Subject: Genesis Top Door Stopper Spacer

Upper Door Stopper Upgrade

This is document number D900000523, Version 1.1.

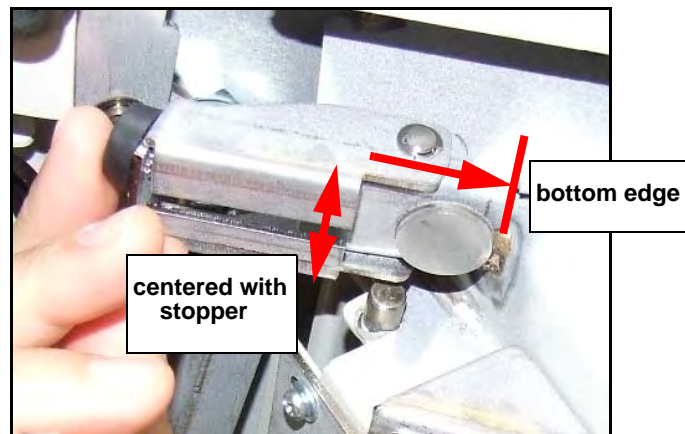
5. Peel off the paper backing on the round spacer (11004612).

6. Stick the round spacer on the upper door frame flange so that it is centered from left to right, and positioned at the bottom edge.

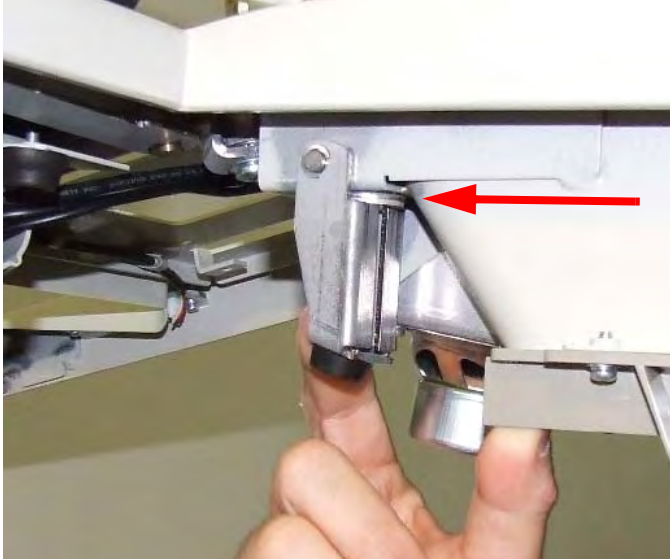
7. Apply pressure for 10 seconds to ensure proper adhesion of the round spacer to the frame.

8. Verify that the stopper is centered on the round spacer when held up against the door frame and that the round spacer has been properly adhered.

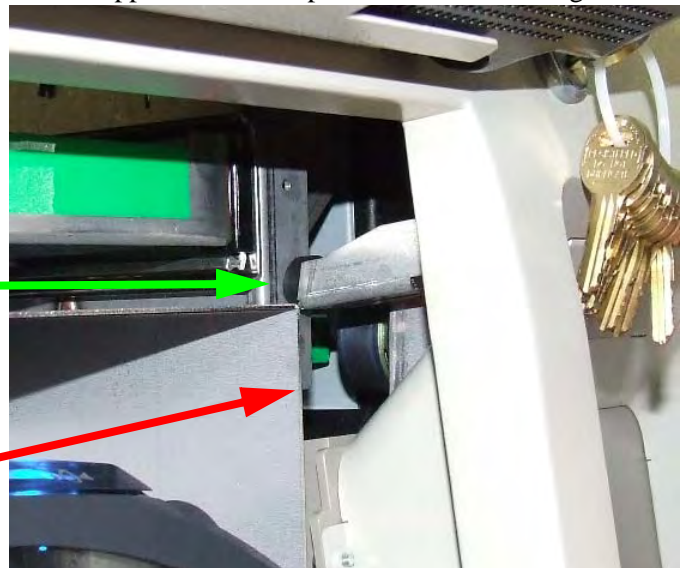
the stopper strikes the
(vertical) middle of the
casing frame flange

the stopper cannot
slip below the flange

9. Open and close the upper door a few times, ensuring that the stopper meets the casing frame flange in the center, and that the stopper does not slip down below the flange.
